Type your content here ...Revise the Intended Use and Notes to Table 17.1 (j) to read:

## Public Input No. 122-NFPA 58-2025 [ Global Input ]

**Figure A.6.15.2**

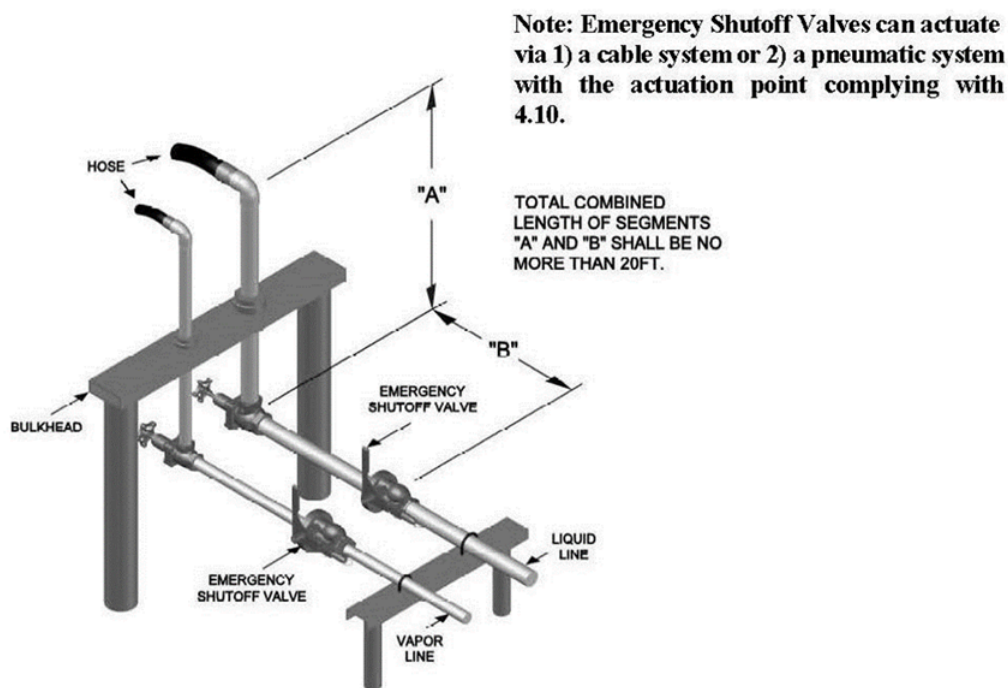
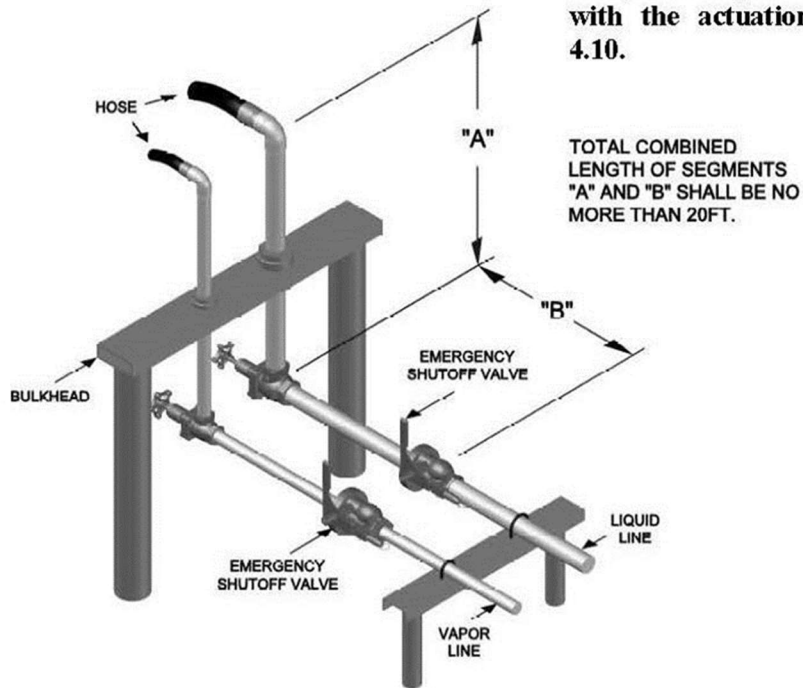
**A.6.15.2** Unless compliance with 6.15.3 or 6.15.5 is achieved, the emergency shutoff valve is required in the lines as specified in 6.15.1 regardless of how much pipe is installed between the connection to the nearest end of the hose or swivel-type piping and the container valve. The 20 ft. distance requirement is provided for instruction on the installation location for the emergency shutoff valves. The total distance is not intended to include the length of the hose. See Figure A.6.15.2.

The code needs to provide clarity as to what is required. New language needs to be provided that will provide clearer requirements for these valves – one of which is a container requirement (internal valve) and the other which is a piping requirement (ESV). Code references 6.15.1 and 6.15.2 need to be clearer so that no misunderstanding occurs for the installation of these vital safety valves.

**Statement:** The annex explanation and requirement language is being added to clarify where the measurement of the lineal piping begins, which is exclusive of hose or swivel piping as that is variable in its length.

**Note: Emergency Shutoff Valves can actuate via 1) a cable system or 2) a pneumatic system with the actuation point complying with 4.10.**
